Re: Landfill Proposal by SITA on Allawuna Farm – Lots 9926, 4869, 5931 and 26934 Great Southern Highway, St. Ronan's, York, WA.

Submission on Planned Proposal - Allawuna Landfill Facility

Attention: Shire Planner

Figure 2.1 Topography and physiographic divisions

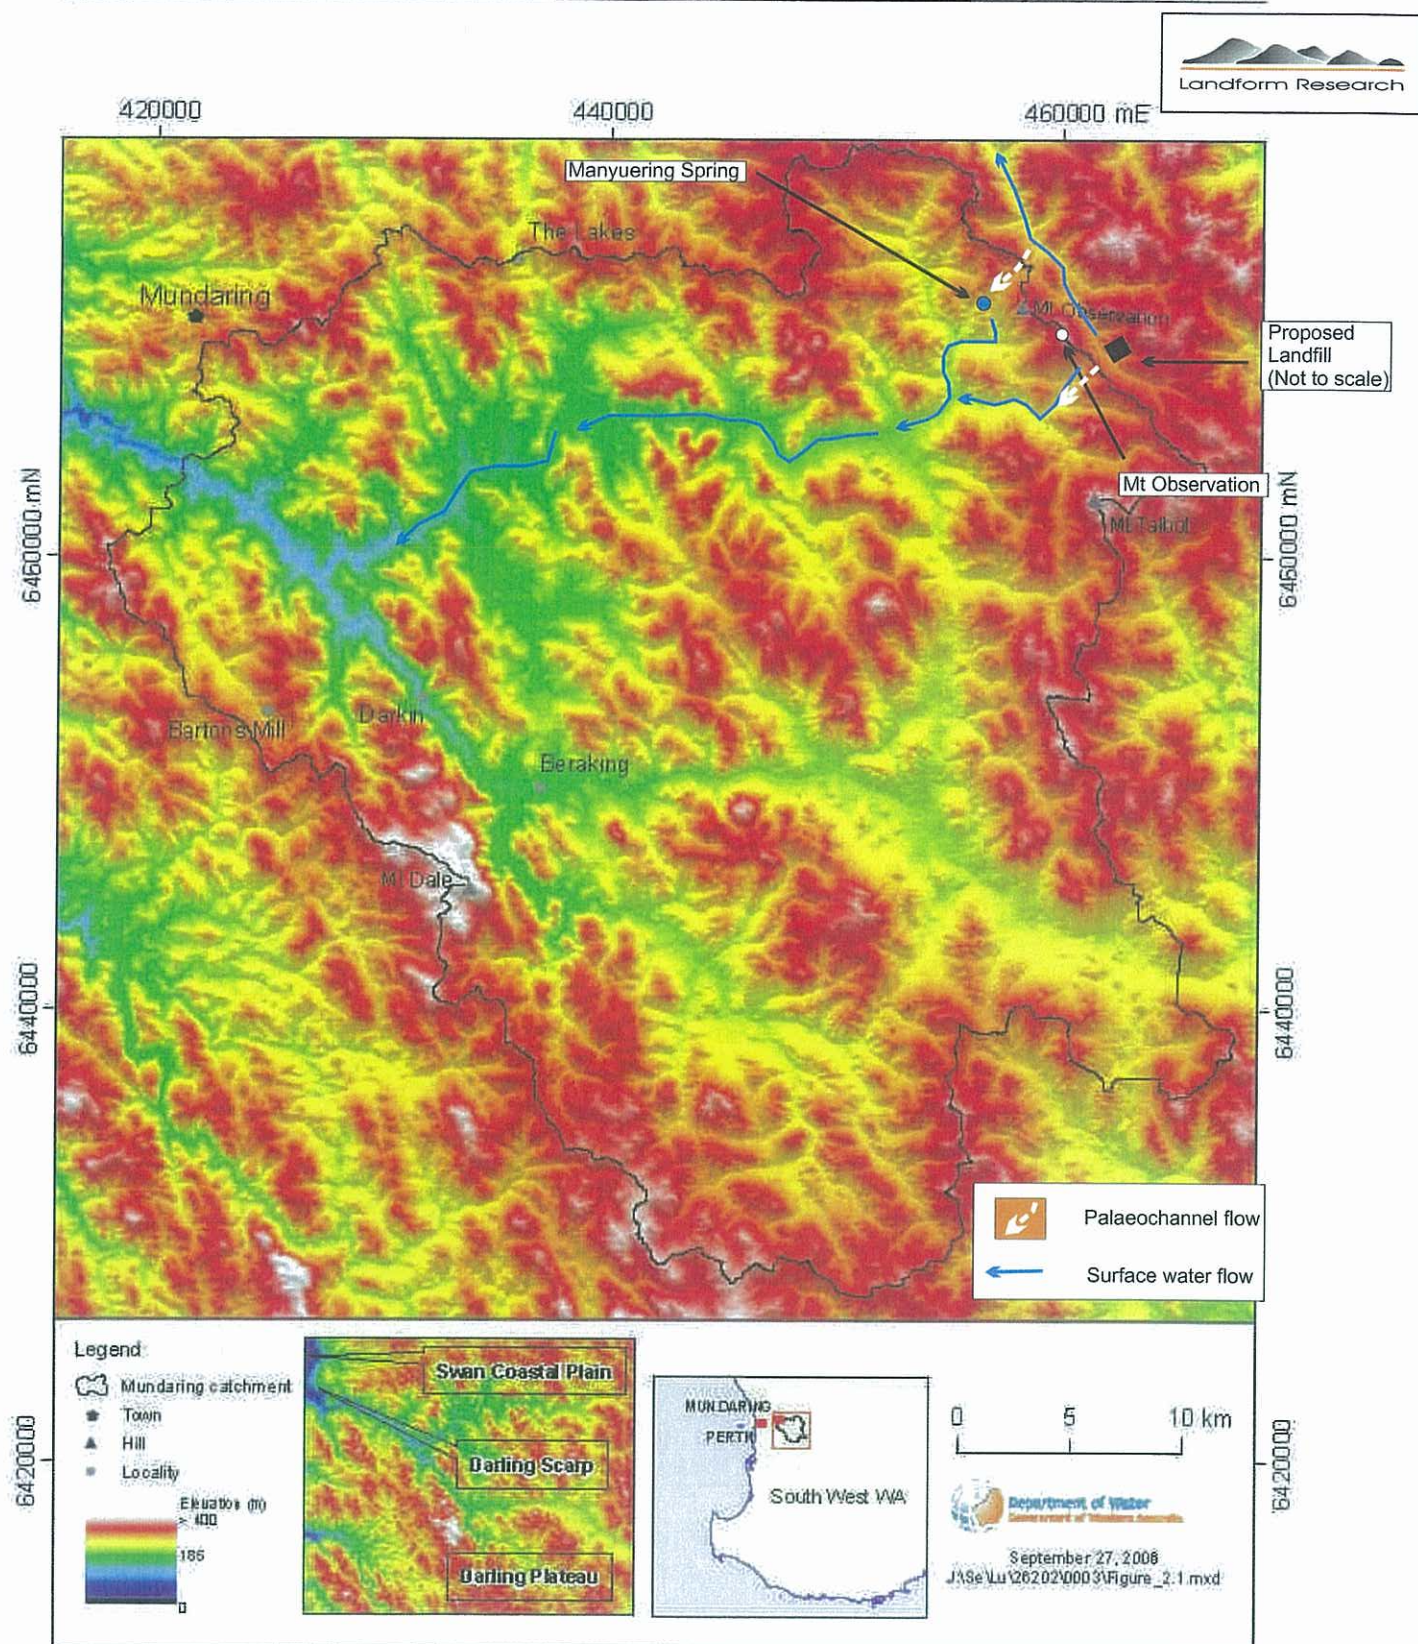
Mapping does not show the palaeochannel flows under the surface water drainage divide

Surface water flows outside the Helena Catchment.

Palaeochannel flow most likely flows into the Helena Catchment

Figure 2.2 Hydrology, subcatchments, gauging stations, rainfall and potential evaporation

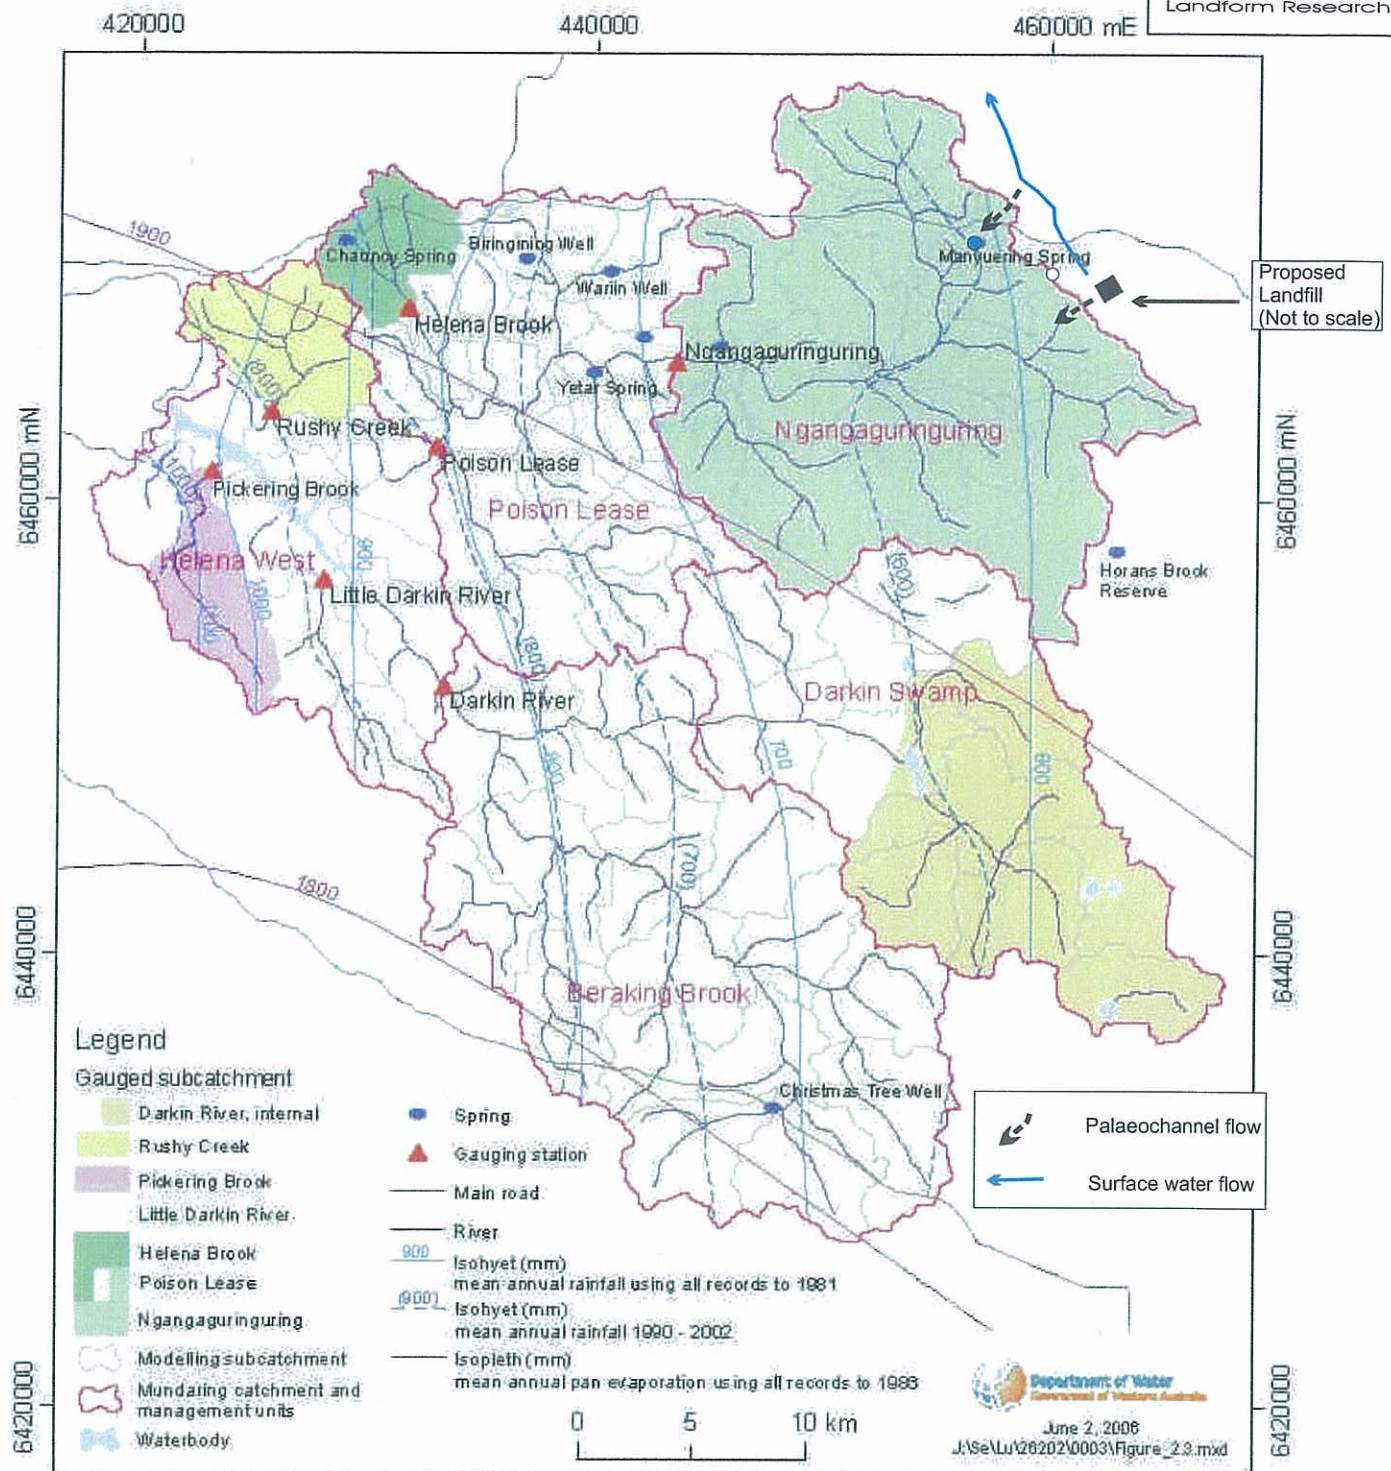
Mapping does not show the palaeochannel flows under the surface water drainage divide

Surface water flows outside the Helena Catchment.

Palaeochannel flow most likely flows into the Helena Catchment

Figure 2.5 Hydrogeology

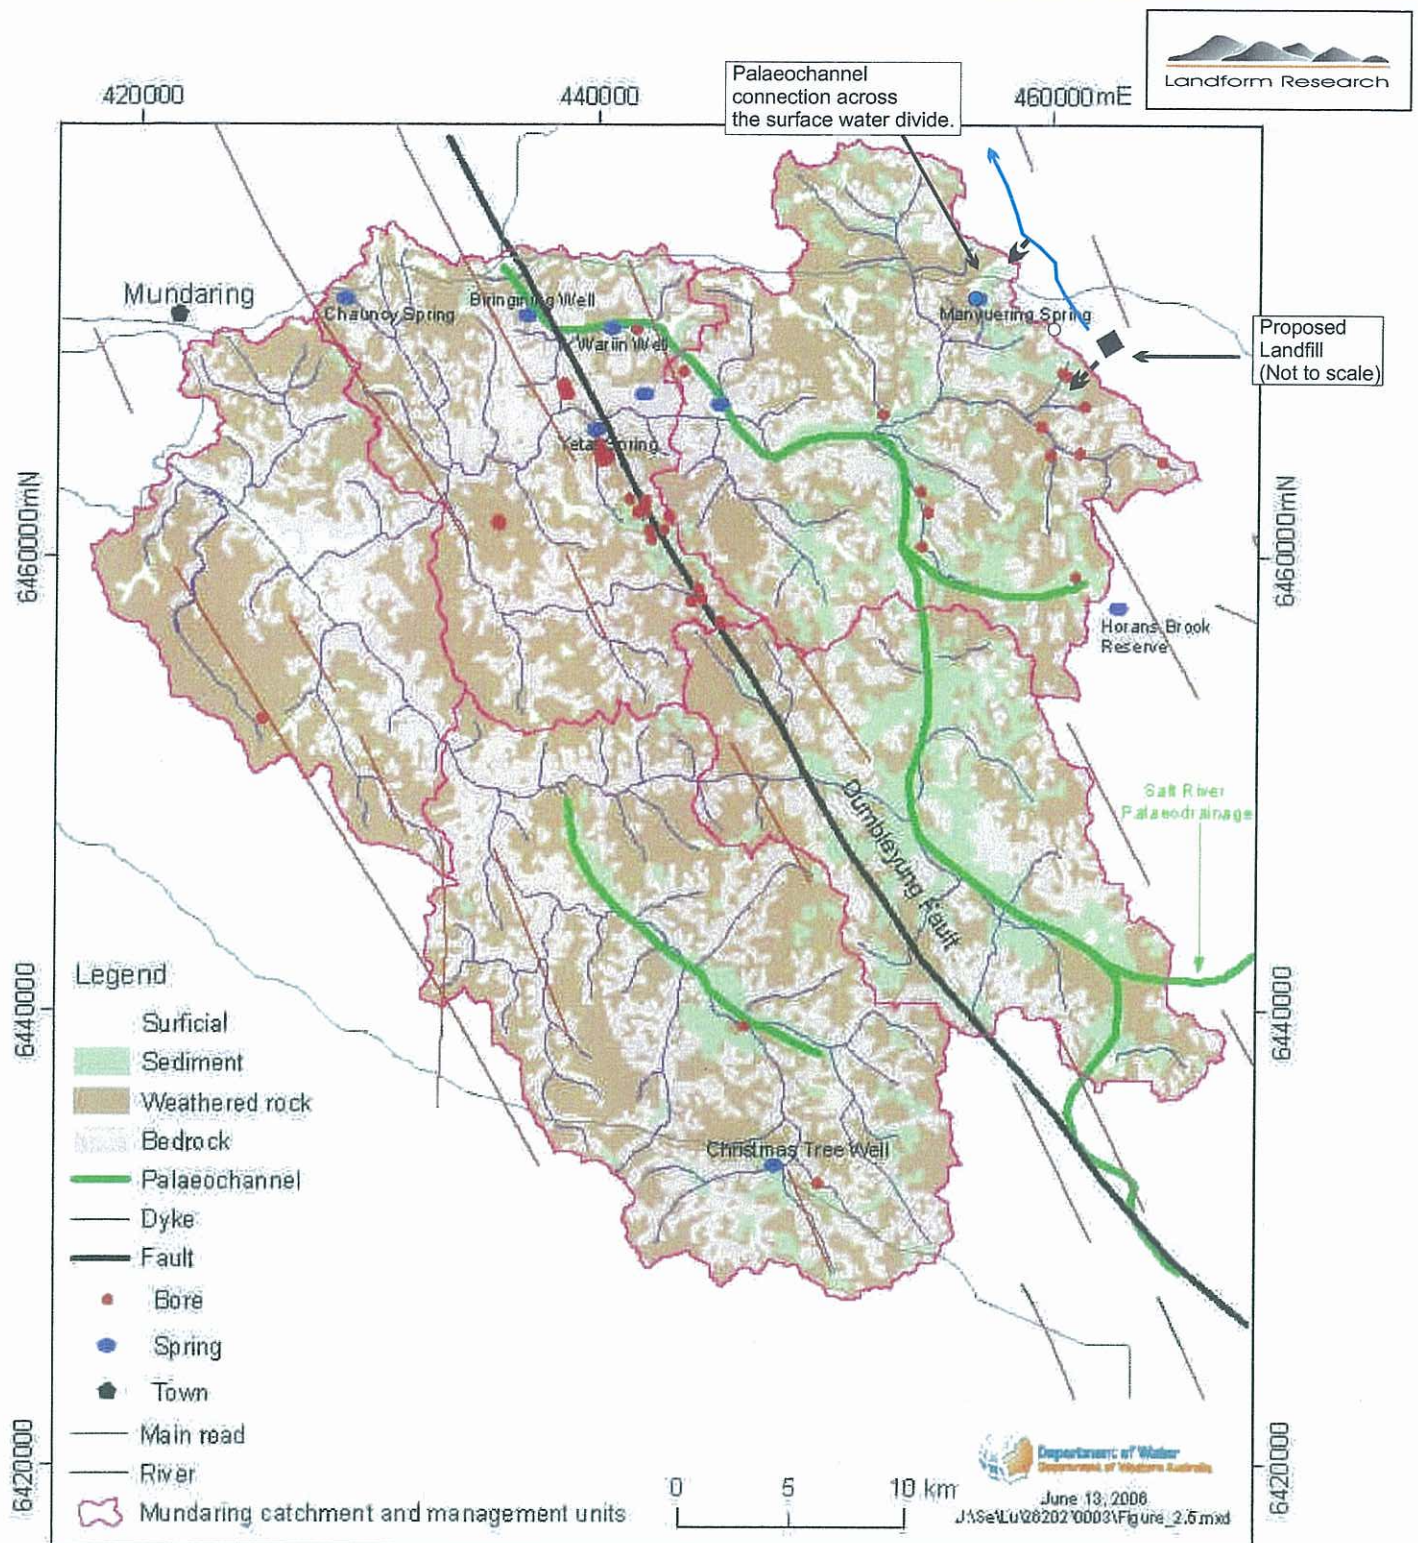
Notice the palaeochannel connection from the valley outside the Helena Catchment to Manyuering Spring, shown in green as sediment. Manyuering Spring probably receives water from the connection to the palaeochannel underlying and parallel to the stream to the north east, outside the Helena Catchment.

Figure 5

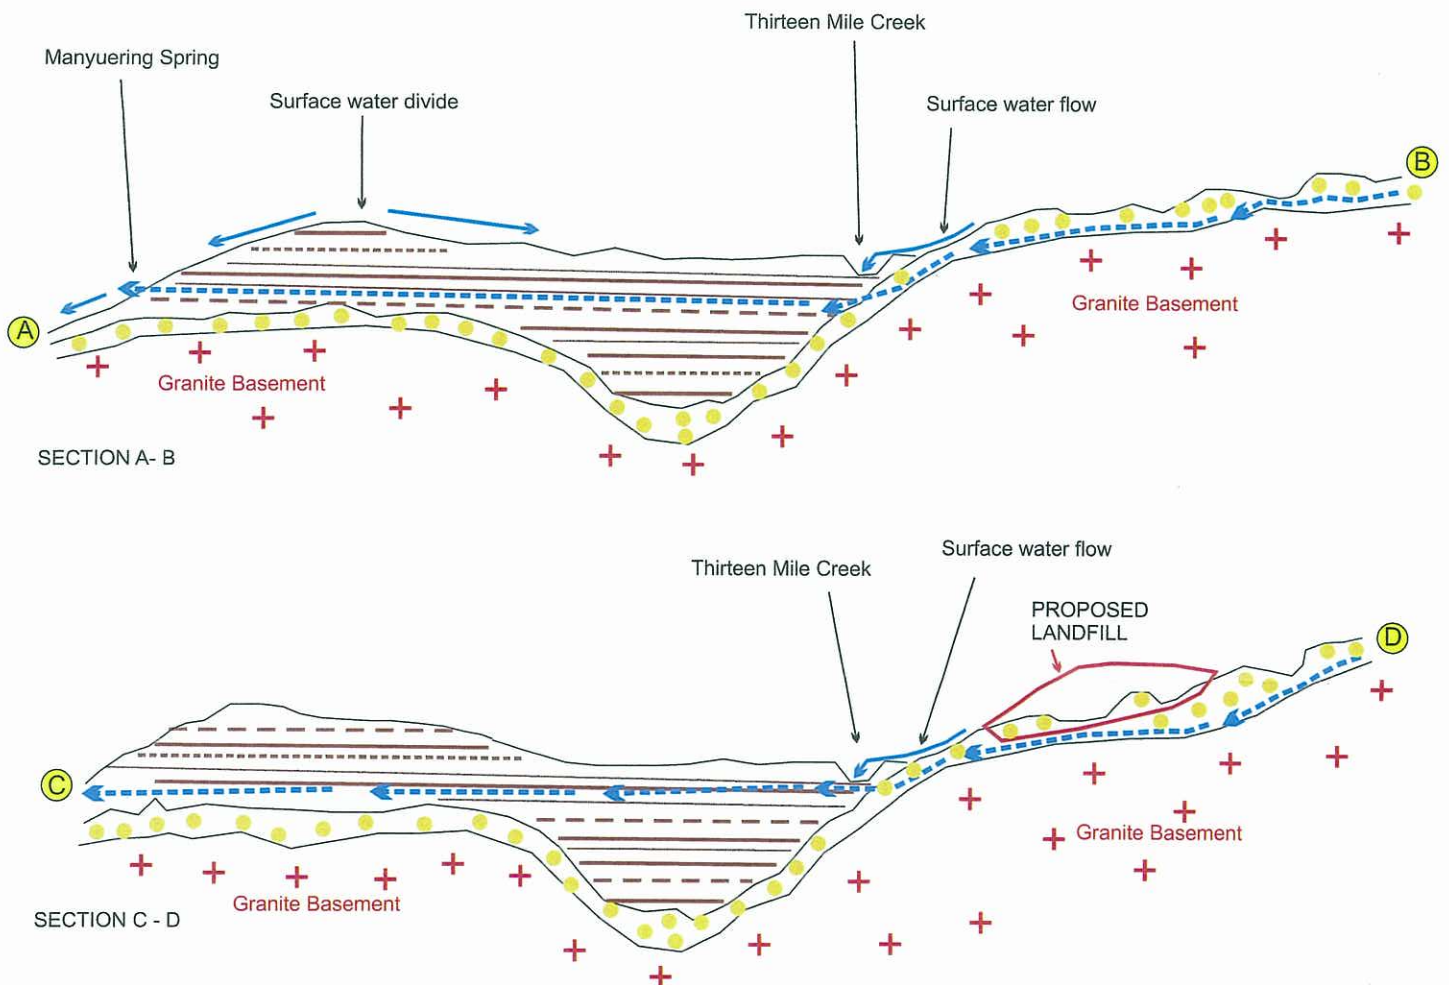
From all the collected material I have provided sketch concept sections of the local area which are presented in Figure 5, based on the published information and material provided by the proponent on DER website. It is unclear why the proponent did not provide such geological material.

FIGURE 6

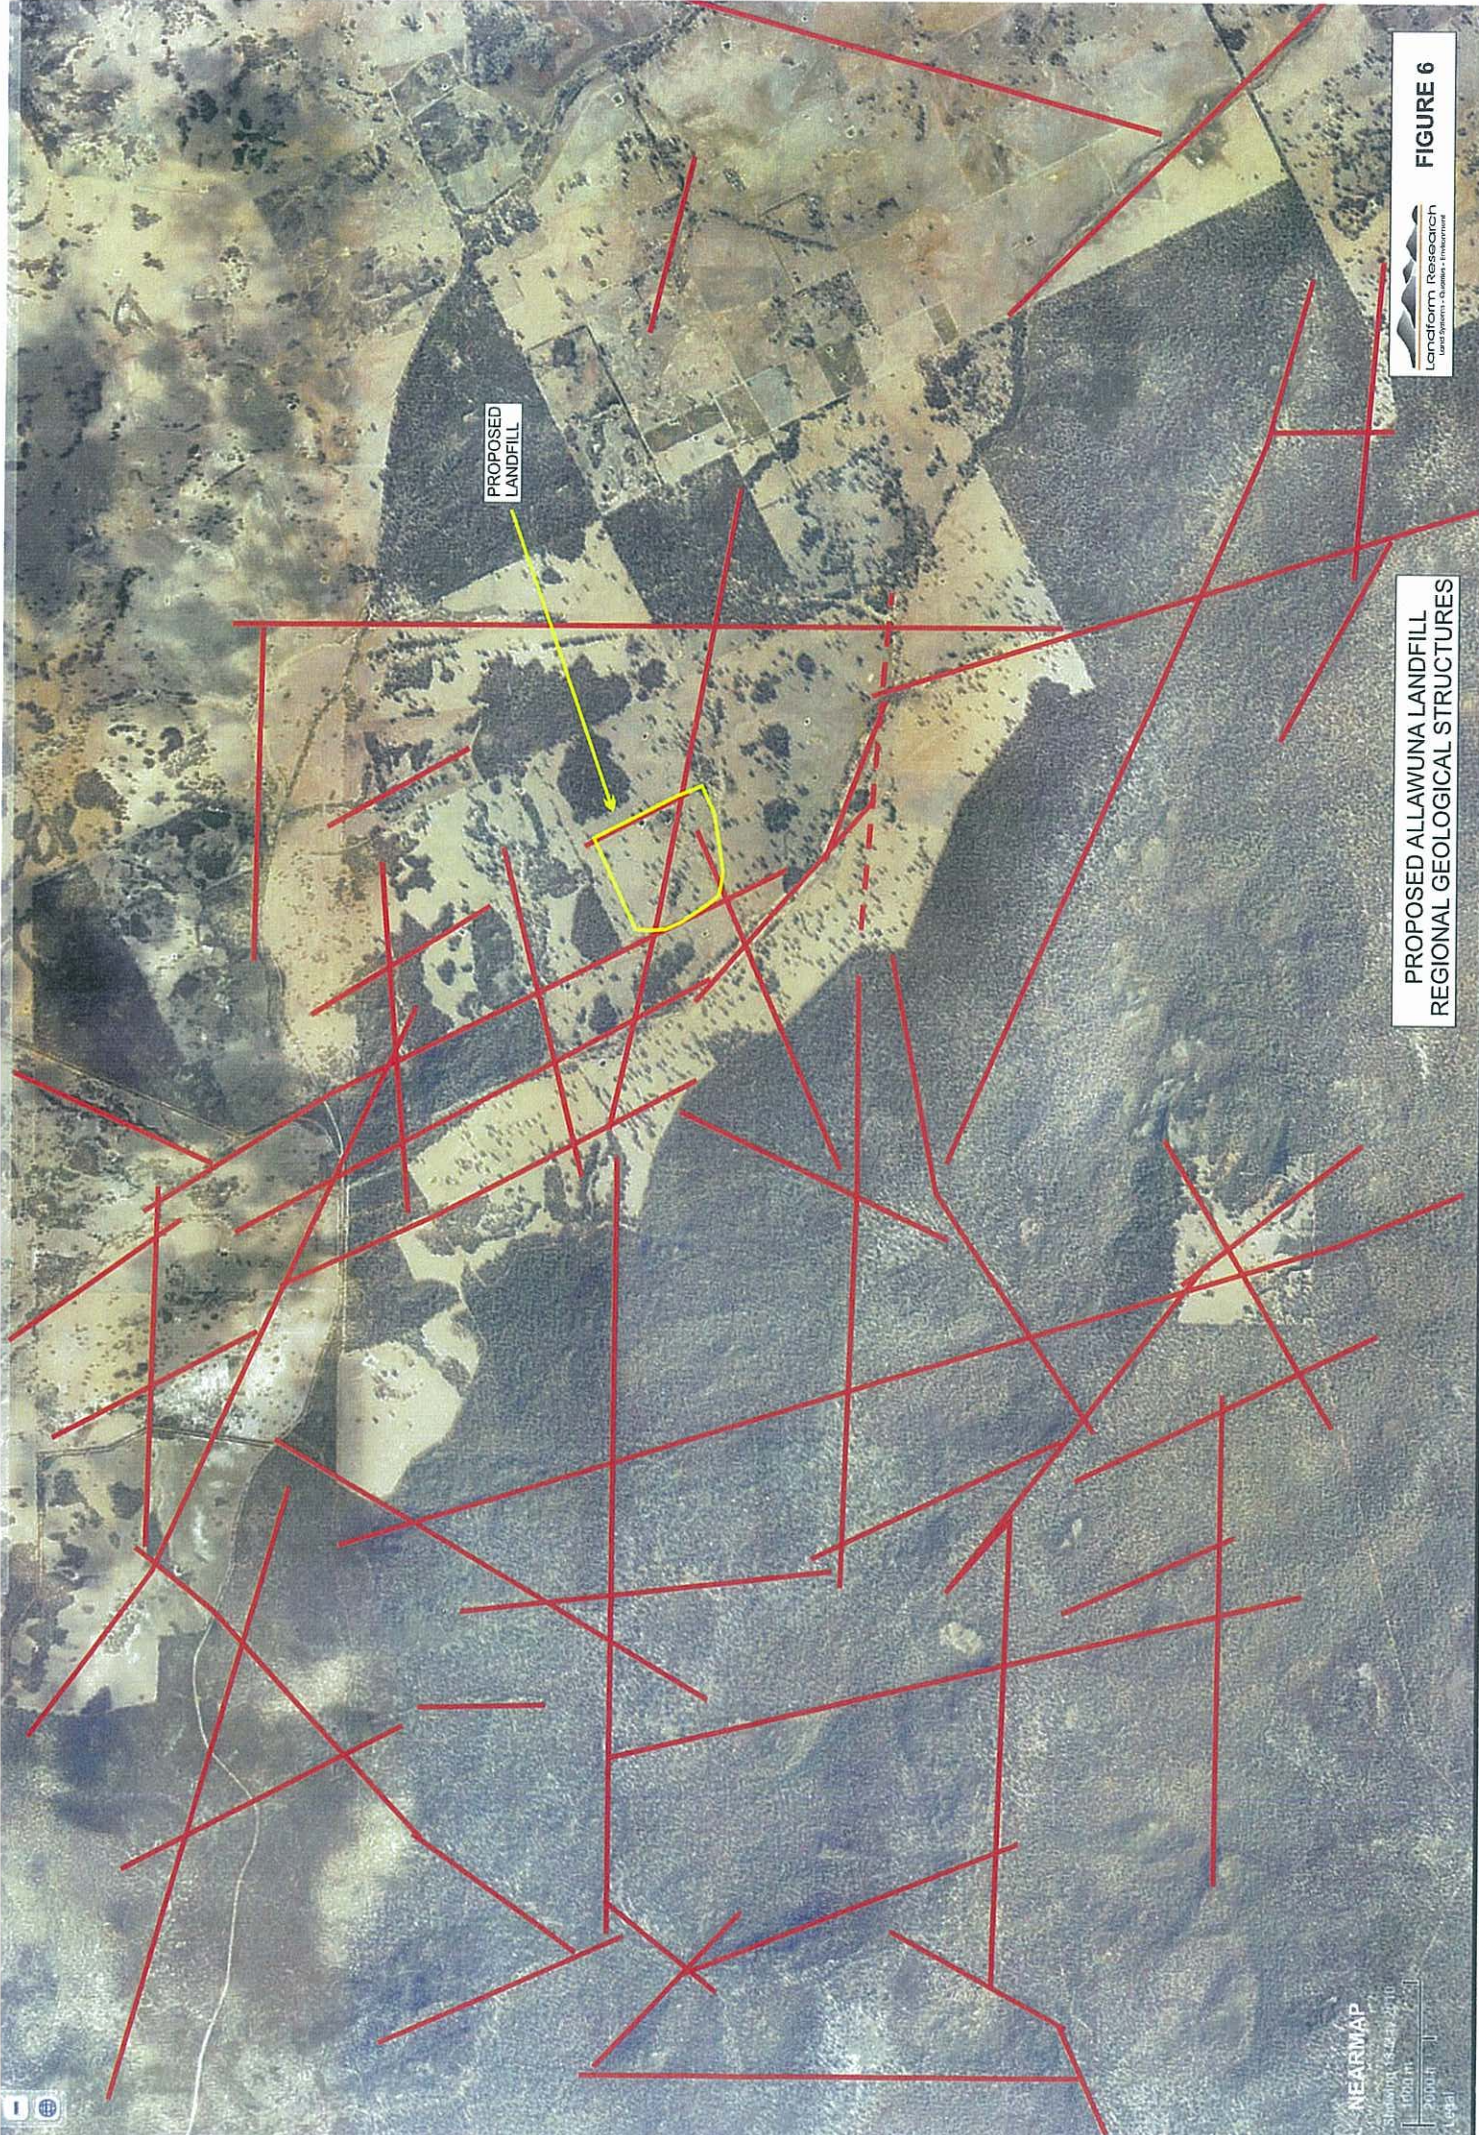
The regional structural geology has been interpreted from aerial photography. These are shown on Figure 6, and provide the lines of weakness along which the palaeo-streams were able to erode. The structural control of the watercourses and valleys is obvious on DOW mapping (Figure 1), shown by the straight lines of the valleys.

Palaeochannel sediments typically do not support dams, and were often in the past accessed by wells. That seems to fit locally. Where are the dams west of the Brook? Except in the south outside the palaeochannel. (Figure 6)
